**CITY OF DELAND
REGULAR MEETING OF THE PLANNING BOARD
JUNE 27, 2024 AT 5:00 PM
CITY HALL, COMMISSION CHAMBERS
120 SOUTH FLORIDA AVENUE**

**PLANNING DEPARTMENT STAFF REPORT
TO
PLANNING BOARD**

APPLICATION: PSB23-029

SUBJECT: Preliminary Plat for Towns at Summit Place

Elevation applies to ROW/open spaces only

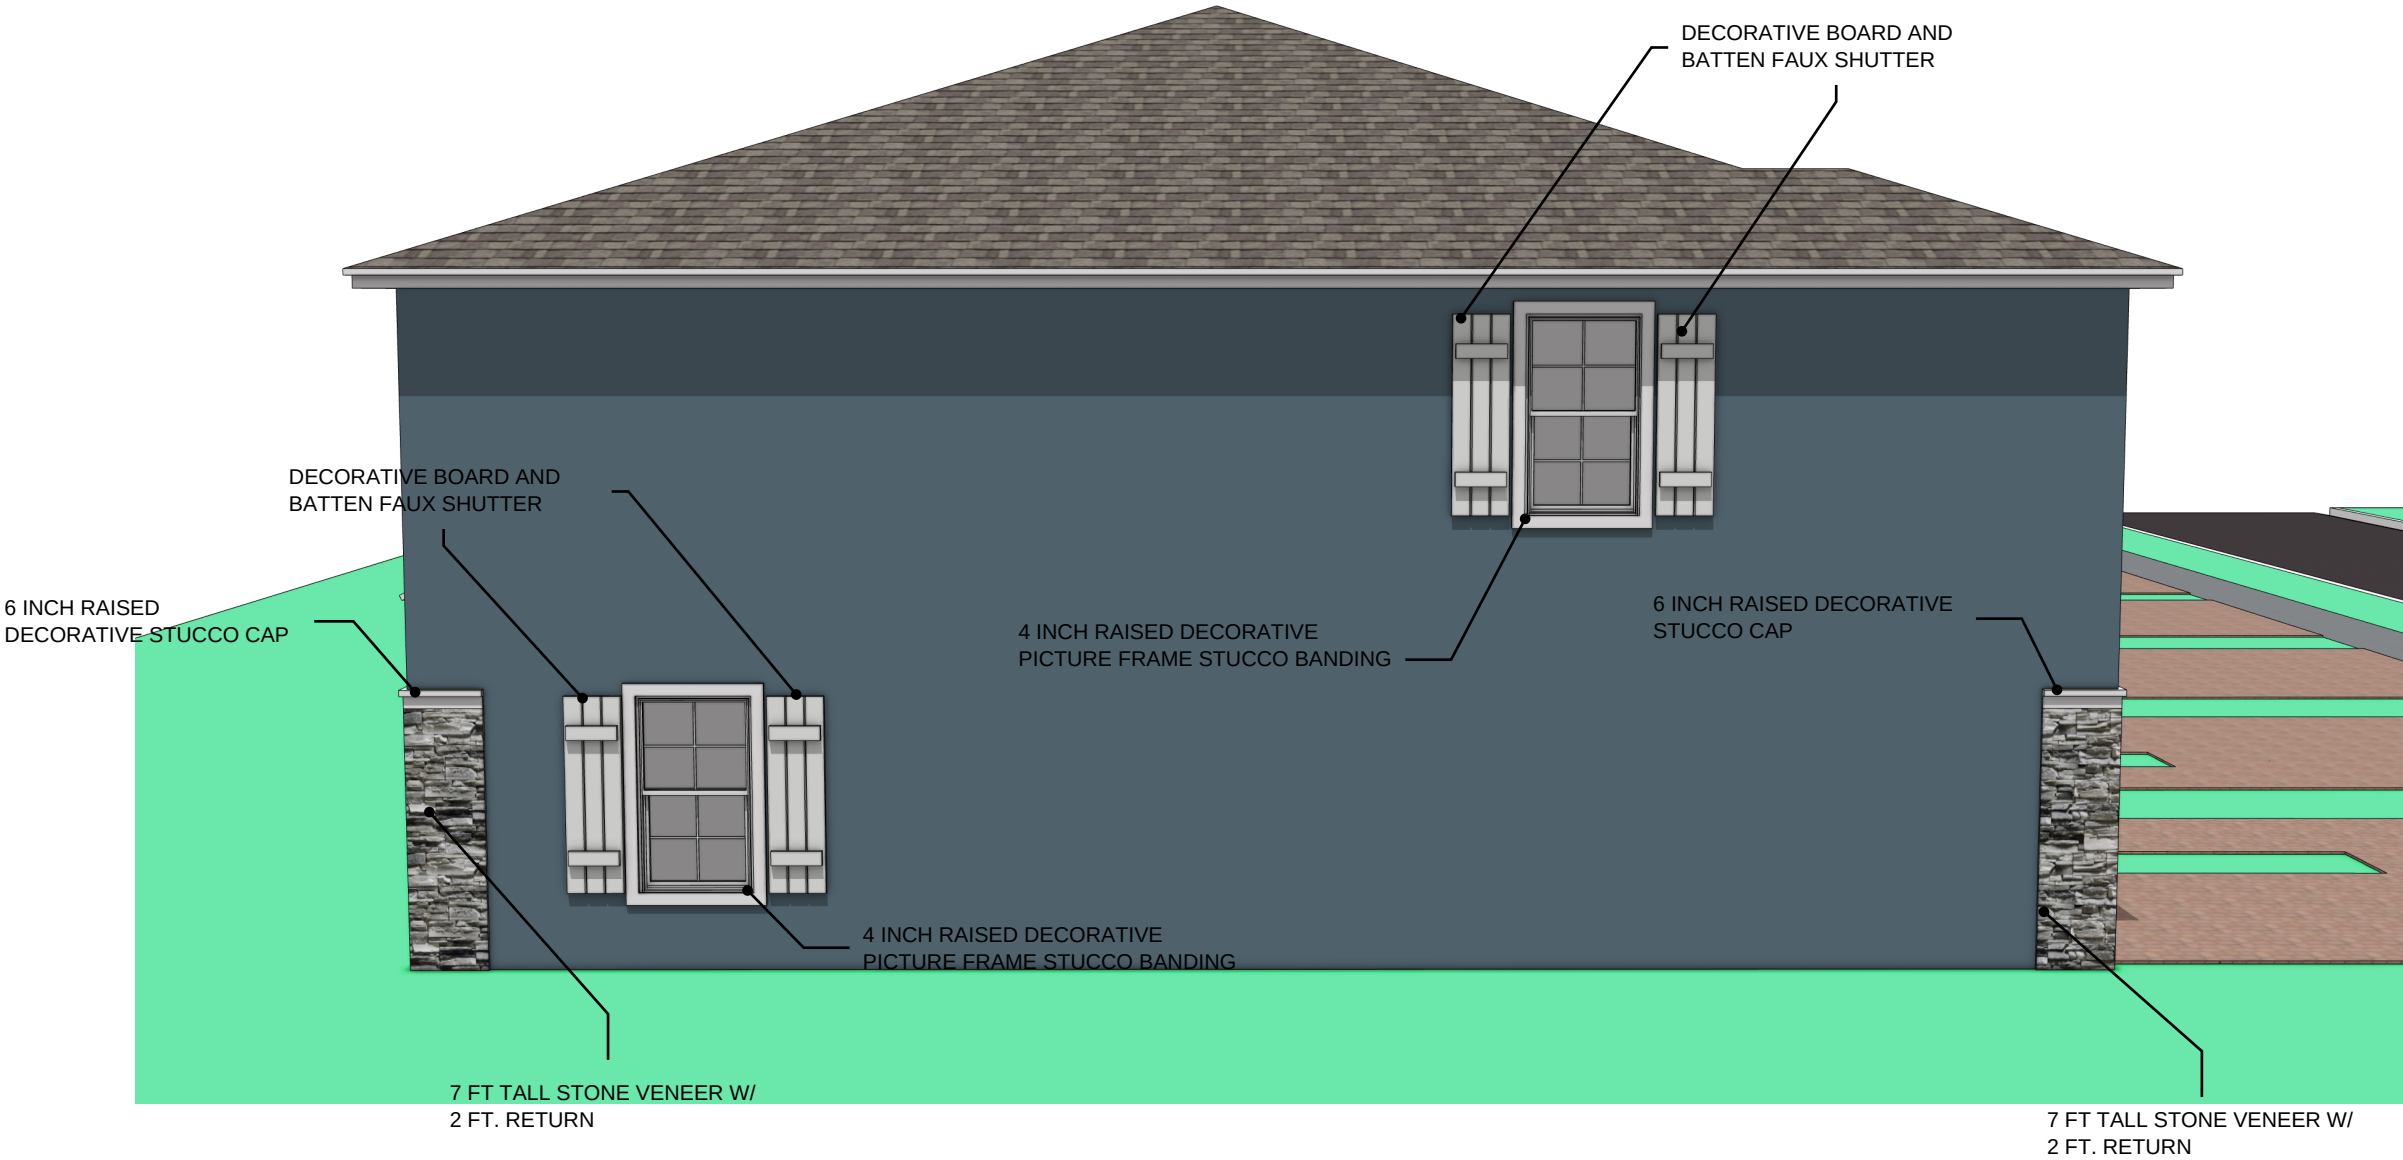
Outstanding Issues: Staff and the City's architect have reviewed the proposed elevations and find that the proposed elevations are not varied thereby creating a monotonous repetition of identical structures on a single site. The applicant has made minor changes, such as altering the shutters on the building facades, but has not adequately varied the building elevations. This monotonous repetition leads to a canyon-like feel throughout the development. The recently-approved Planned Development Agreement includes language regarding consistency with the Community Design Standards. Furthermore, the Lake Winnemissett Local Gateway Plan calls for varied architecture to reduce monotonous appearance of buildings.

Staff and the City's architect have met with the applicant to discuss the need for a variety of facades to limit or reduce the monotonous appearance. This concern has been consistently raised with the applicant since the initial sketch plan application submitted on March 9, 2023.. However, the most recent June 20, 2024 submittal does not reduce or eliminate the monotonous appearance. Staff has provided the applicant examples within the D.R. Horton product line that would address the architectural concerns.

Therefore, staff has included a condition of approval regarding the need for revised architectural elevations to be submitted and reviewed prior to scheduling this item before the City Commission. Enhanced architectural features such as varied porches, garage overhangs, front porch railings, differing materials, siding, and color changes are needed to reduce the monotonous repetition.

The applicant submitted architectural elevations and plans on June 20, 2024 addressing some of remaining staff comments from the June 12, 2024 Planning Board meeting, but staff finds that these architectural elevation revisions do not provide enough variety in materials, rooflines, and façade enhancements to reduce the monotony.

1. All outstanding TRC comments shall be addressed to the satisfaction of City Staff (forestry) prior to scheduling this item for City Commission review.
2. Updated architectural elevations complying with staff recommendations that remove the monotonous appearance and include a variety of materials, colors, and wall plane variation shall be submitted to and signed of by city staff prior to scheduling this item for City Commission consideration.

C100

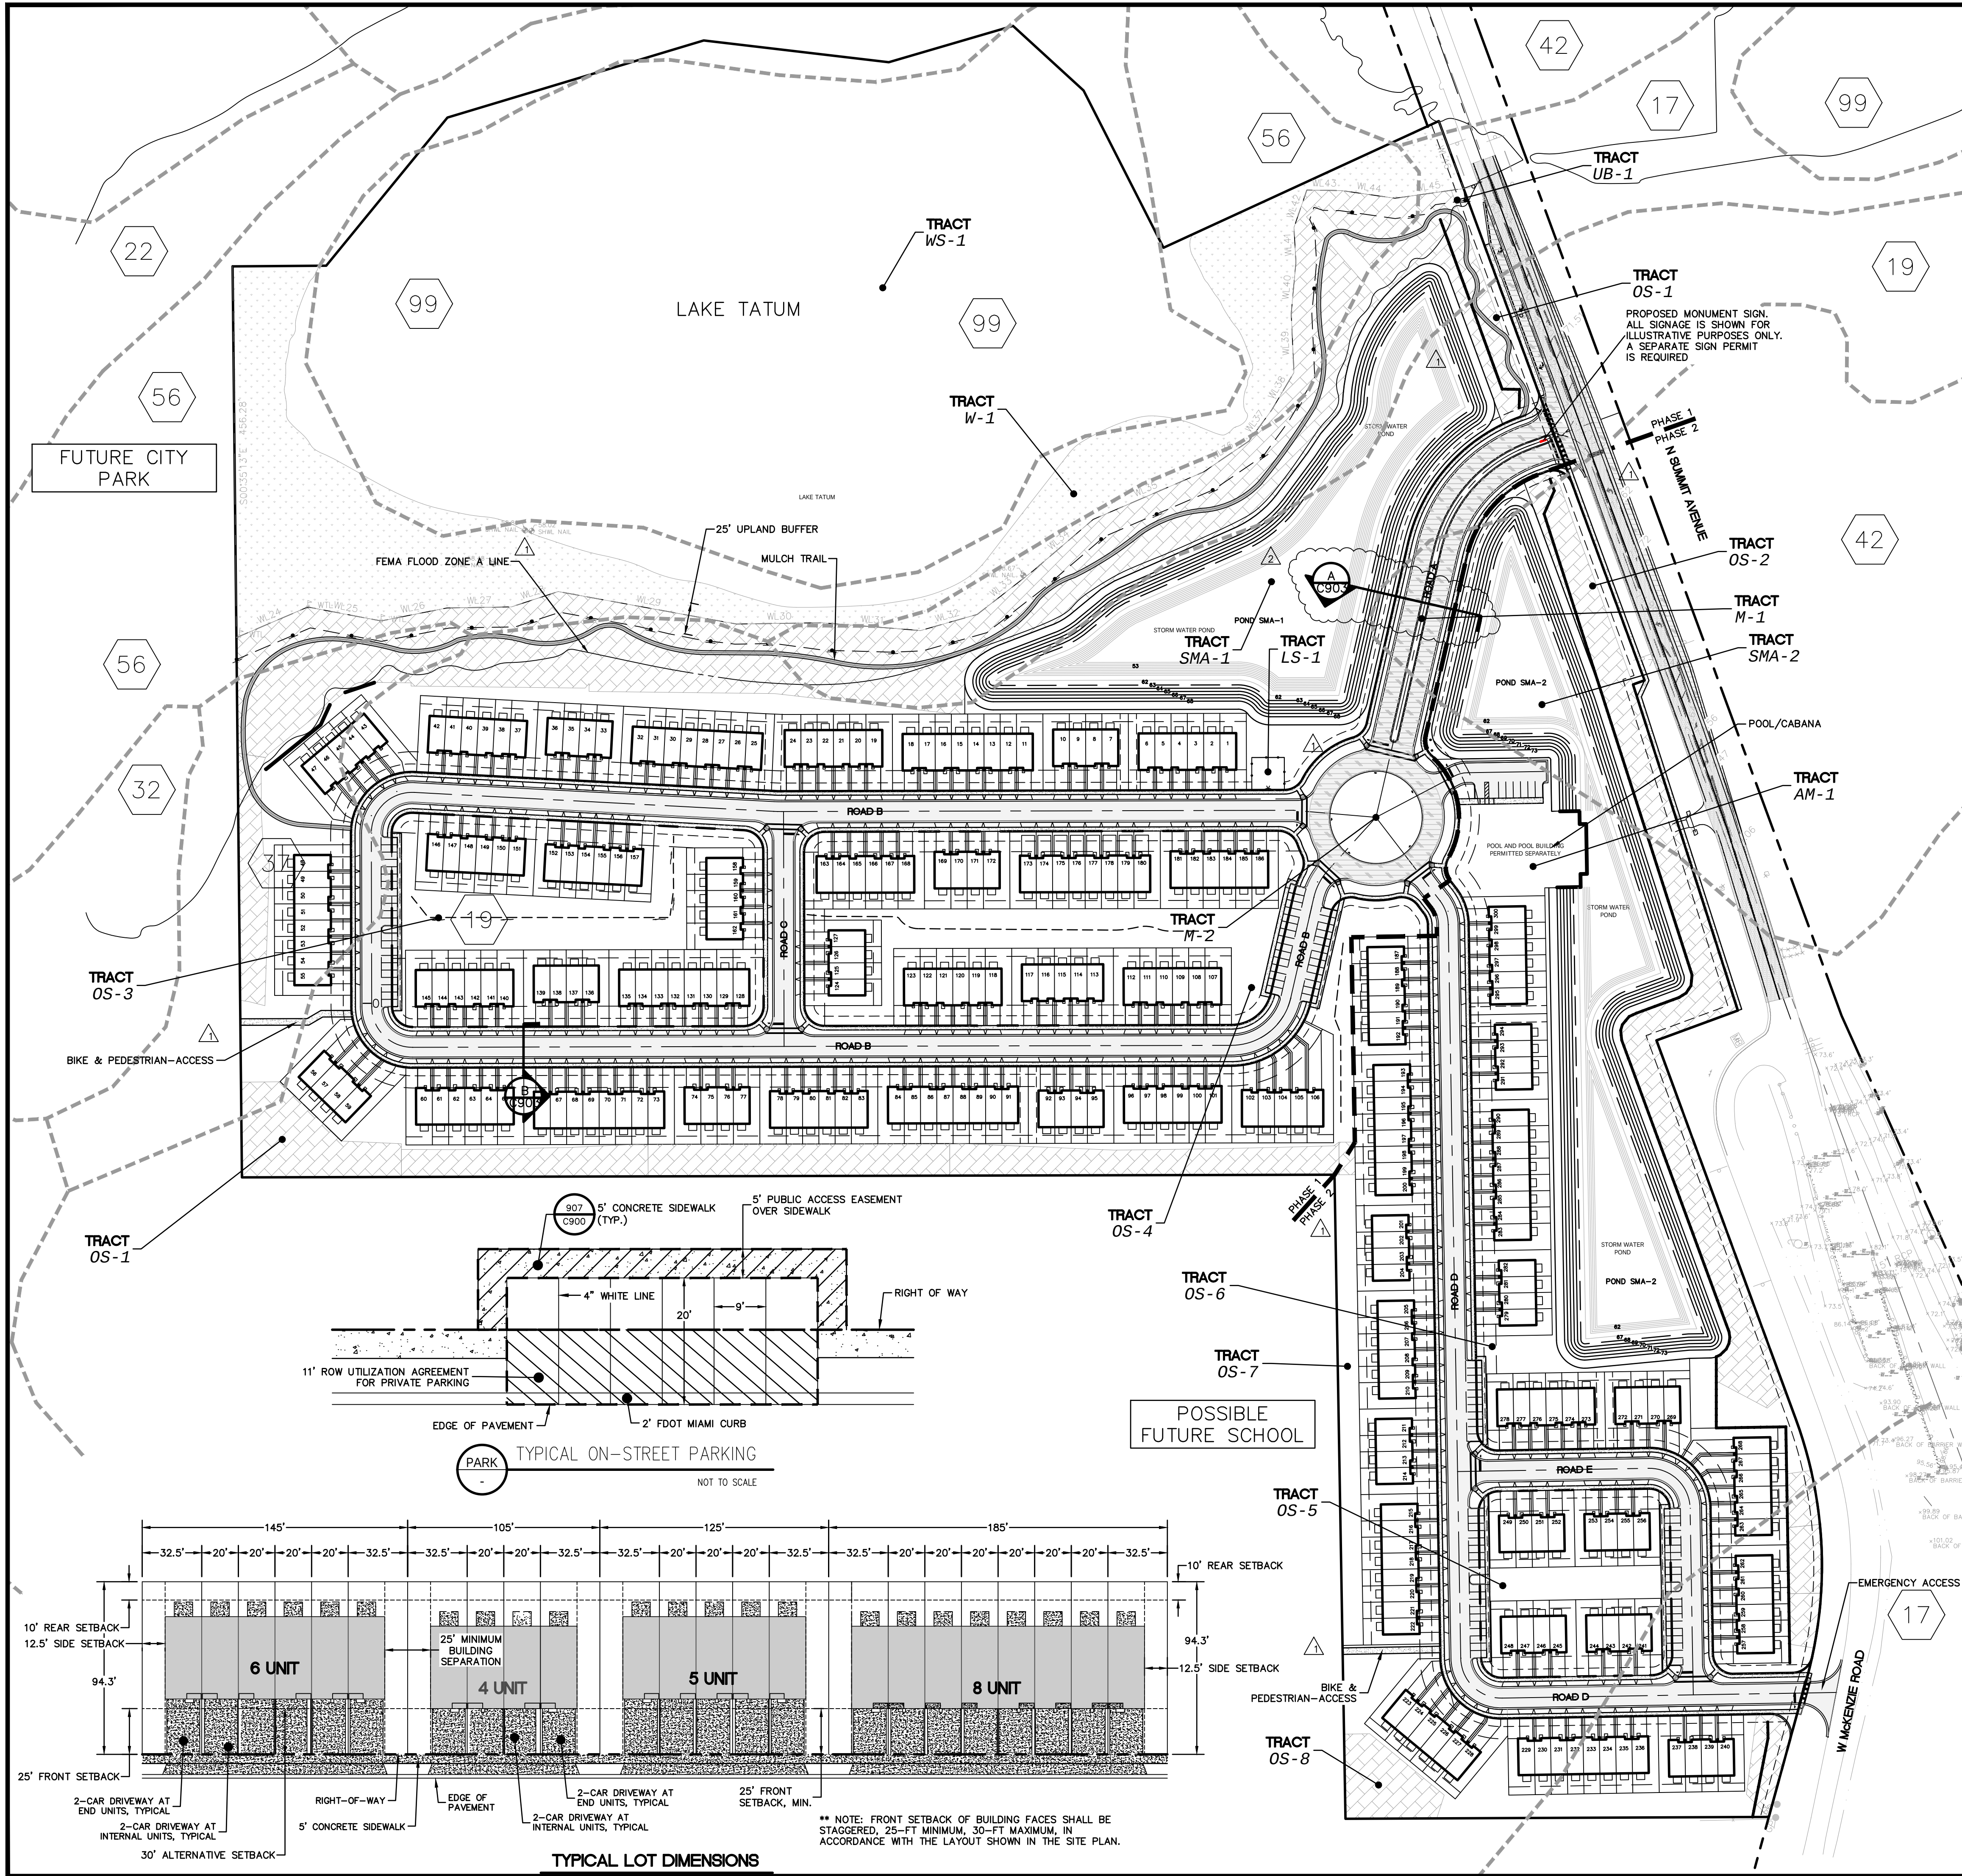
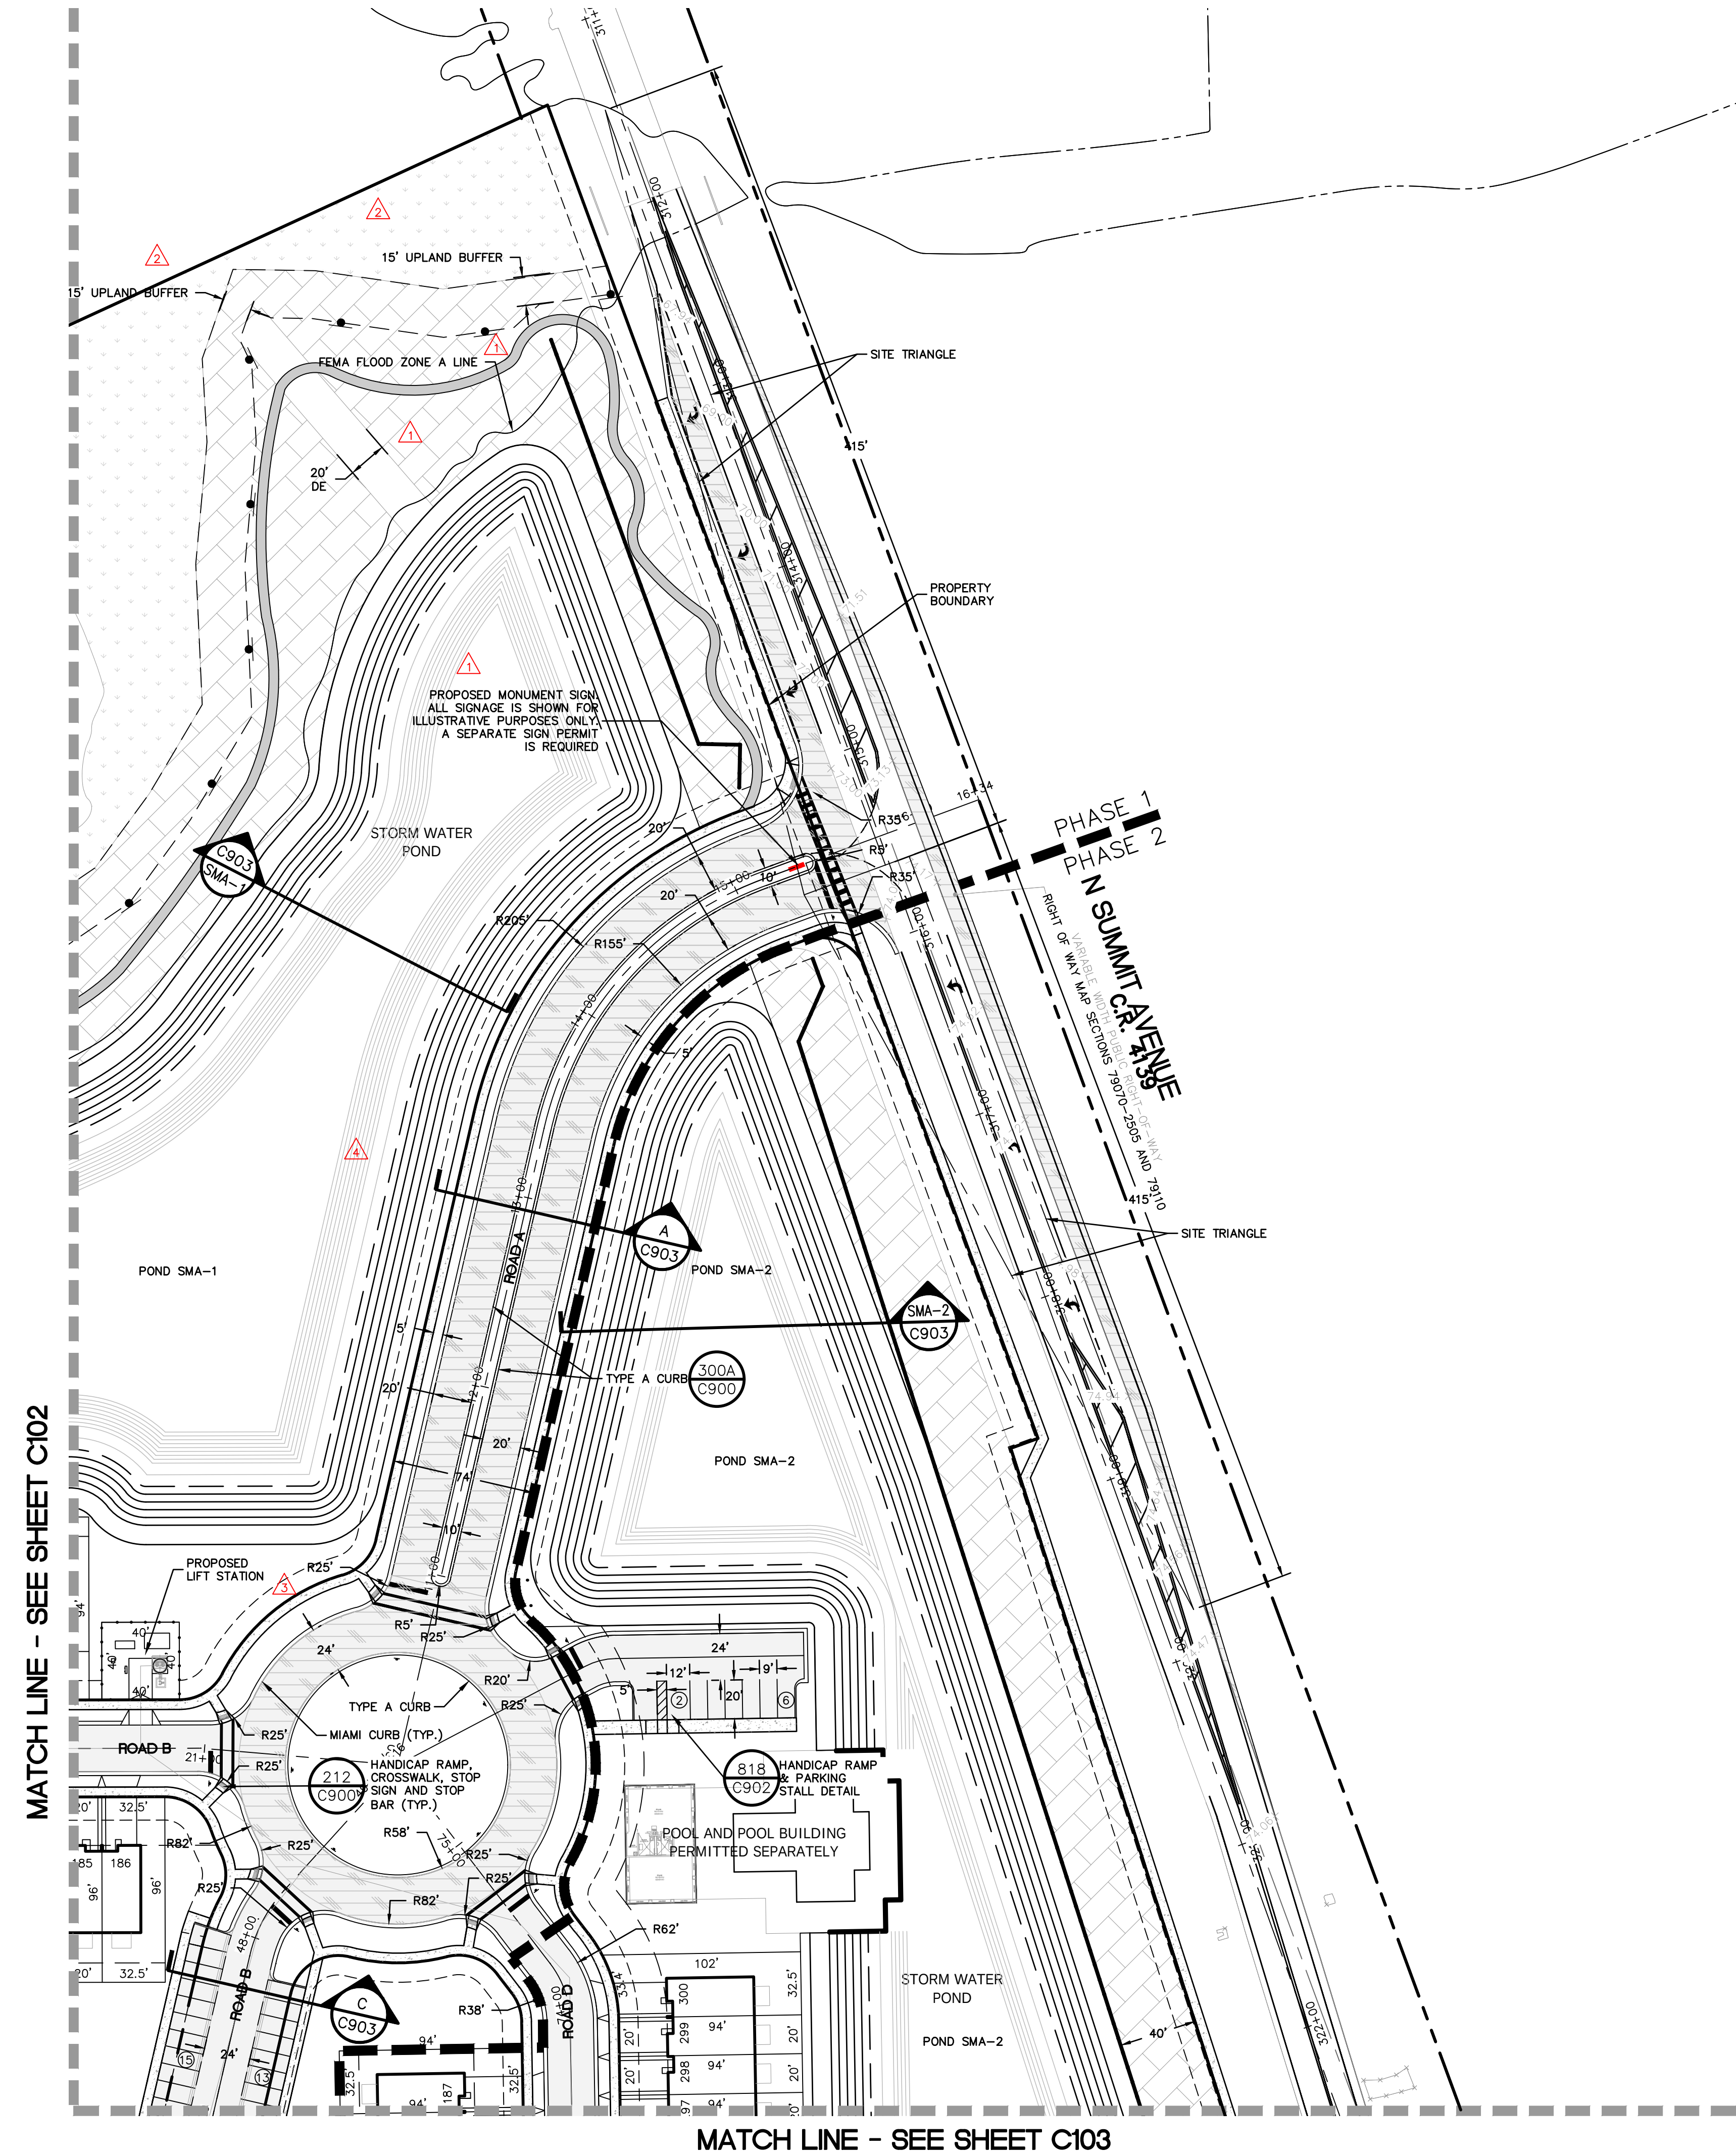
Discipline	Status	Details	Attached To	Created By	Last Updated By	Modifications Required
Forestry	Not Accepted	Tree Protection Notes & Tree Barricade Detail Please replace this information with City of DeLand Tree Barricade Detail and requirements. Last comment from reviewer: Please remove the Tree Protection Notes and detail from this sheet (C011) or replace them with the City's Tree Barricade Detail dated January 11, 2024. Please also replace the detail on sheet C700 with the current version dated January 11, 2024. Last response: The tree protection notes and details have been removed from sheet C010 and are located only on sheet C700.	C011	Mariellen Calabro	Kit Dennis	Yes
Planning	Not Accepted	Architecture - Community Design Standards Please revise the site plan to meet the requirements listed in the Community Design Standards (Section 33-94). The elevations do not appear to comply with the City's Community Design Standards. Please revise the elevations to meet these standards. The resubmittal should describe how these standards are being met. Last comment from reviewer: Repeat comment - Revise the elevations to adhere to the City's Community Design Standards, removing the monotony. Last response: Please see the attached revised building elevations.	C100	Melissa Winsett	Emily Ragusa	Yes
